ACCESSION NBR: 8305020453 DOC. DATE: 83/04/26 NOTARIZED: YES DOCKET #
 FACIL: 50-261 H. B. Robinson Plant, Unit 2, Carolina Power and Light 05000261
 AUTH. NAME: EURY, L.W. AUTHOR AFFILIATION: Carolina Power & Light Co.
 RECIP. NAME: EISENHUT, D.G. RECIPIENT AFFILIATION: Division of Licensing

SUBJECT: Forwards addl info per NRC 821210 request re Generic Ltr
 reactor vessel level instrumentation sys completed. Sys
 installation 30% complete.

H. B. ROBINSON STEAM ELECTRIC PLANT, UNIT NO. 2
DOCKET NO. 50-261
LICENSE NO. DPR-23
INADEQUATE CORE COOLING INSTRUMENTATION
SYSTEM (GENERIC LETTER 82-28)

FIGURE 1. DISTRIBUTION OF FLUX THIMBLES AND THERMCPLS.

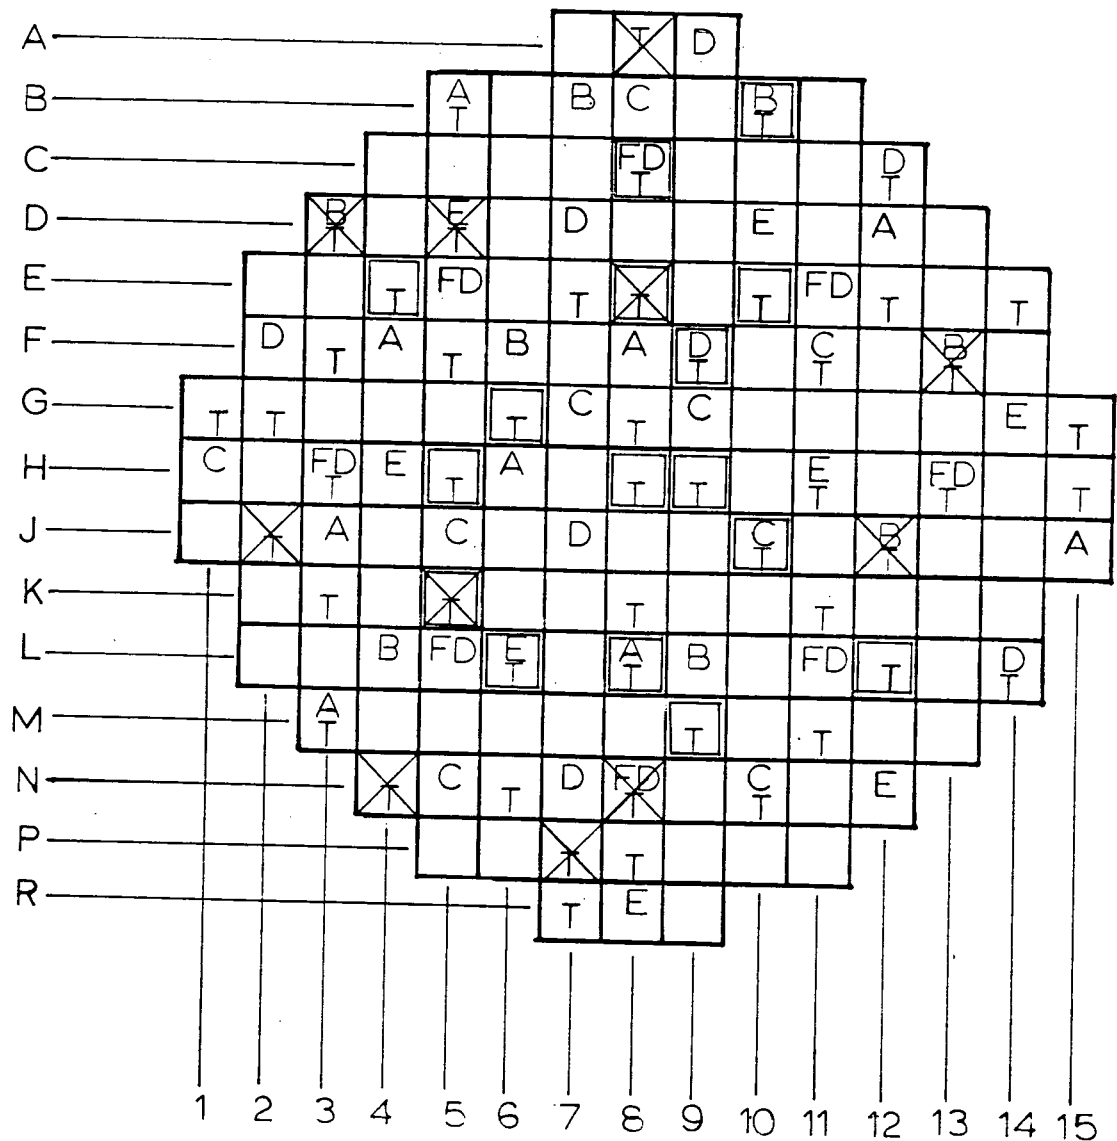
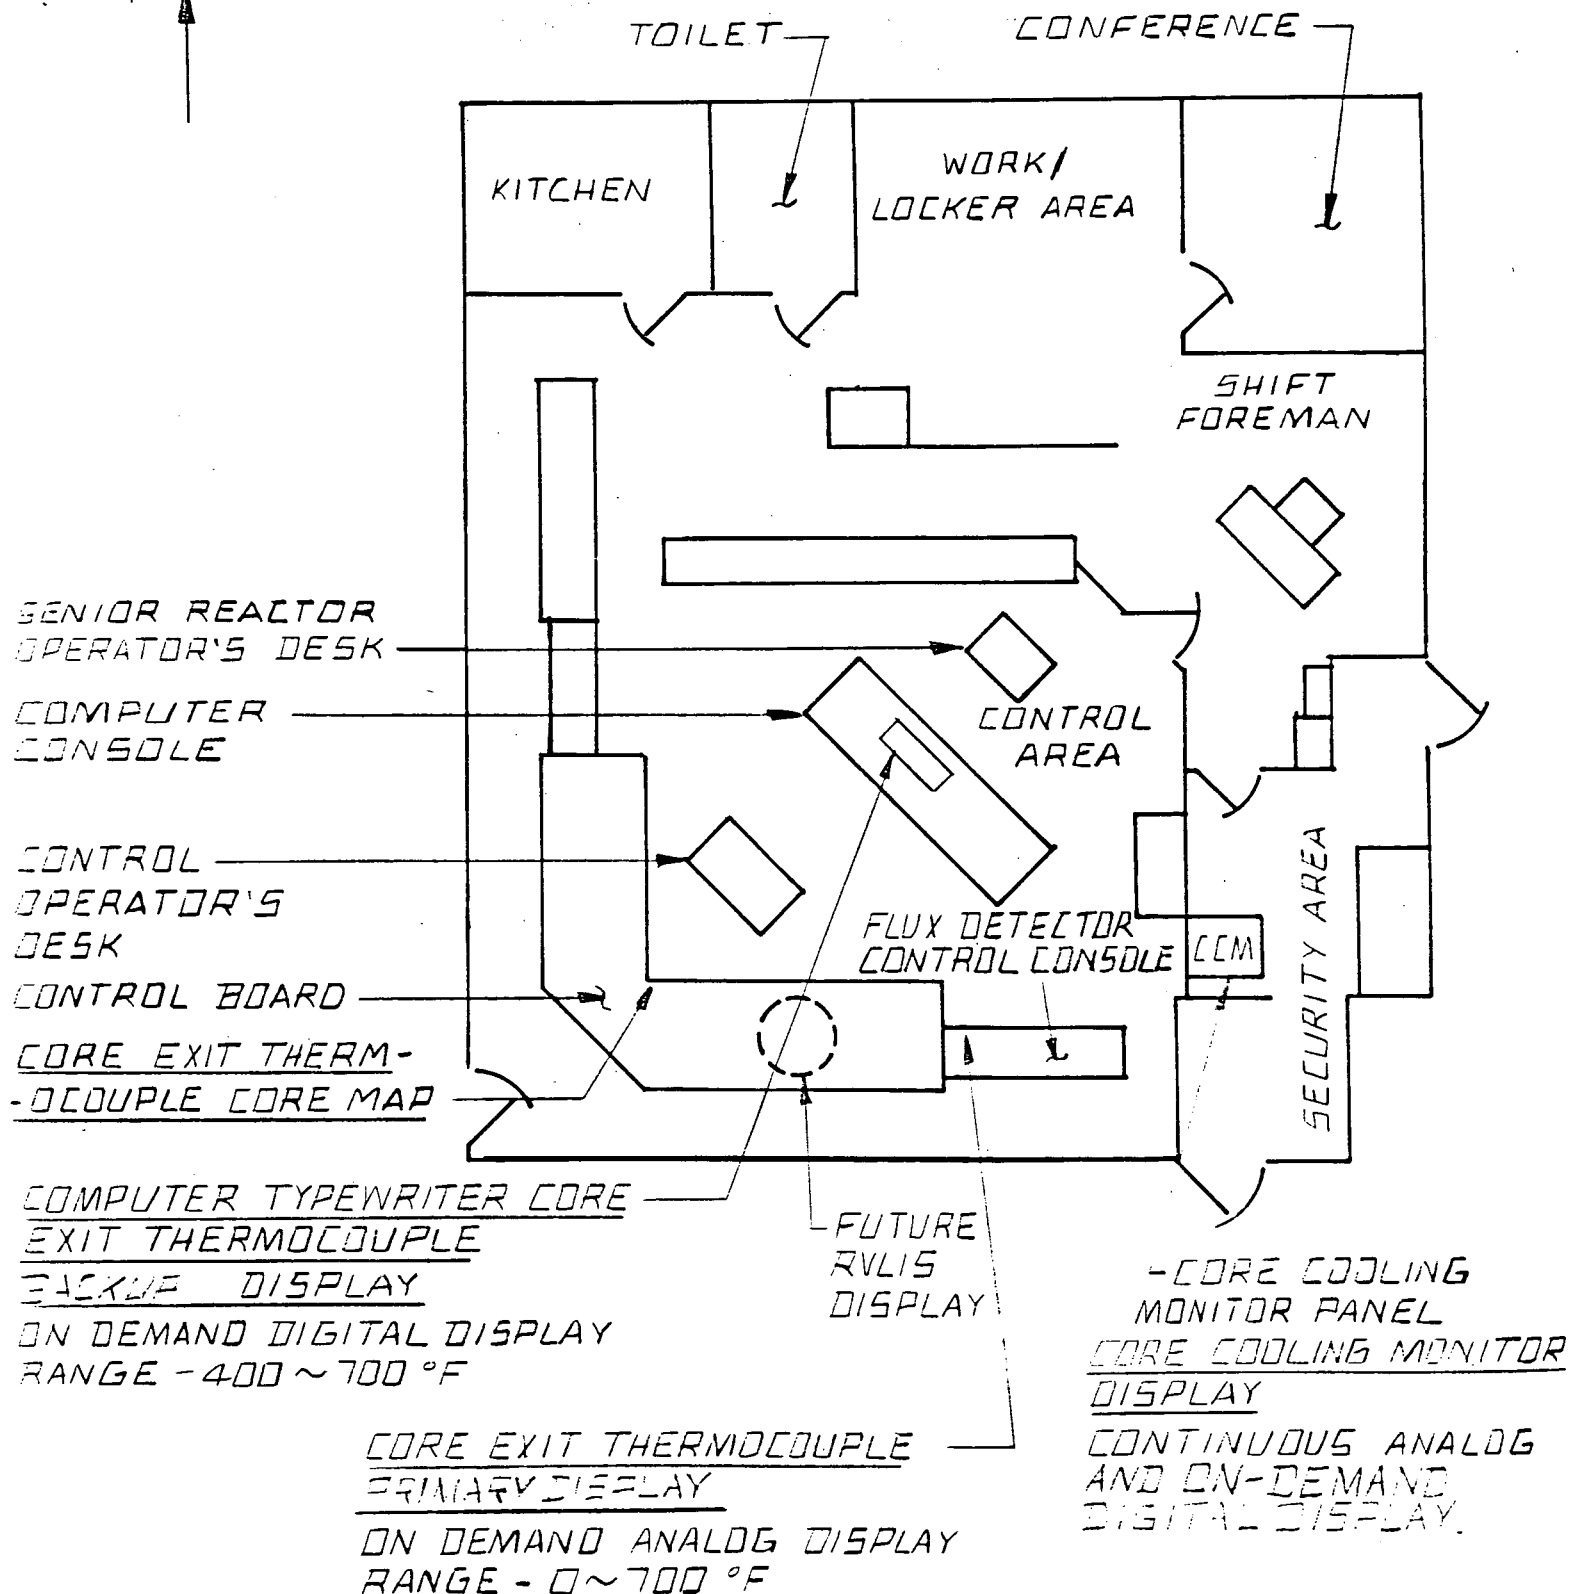
1. Provide diagram of core-exit thermocouple locations

The Core Cooling Monitor is described in detail in our letter, Serial No. GD-79-3306, dated December 31, 1979, and in our letter, Serial No. NO-81-569, dated March 31, 1981. The Core Cooling Monitor for HBR2 is installed and operational at the present time. The Core Cooling Monitor Thermocouple locations are shown in Figure 1.

display unit. Thus, it possesses the required redundancy (for each of the four (4) core regions) in that it is comprised of two (2) channels which operate completely independent of each other. The functional thermocouples on the Core Cooling Monitor are also capable of being monitored by a manually switchable precision indicator and the P-250 computer. The locations of the thermocouples are shown in Figure 1. These readings are used to determine the margin-to-saturation.

The location of the Core-Exit Thermocouples is identified in Figure 1.
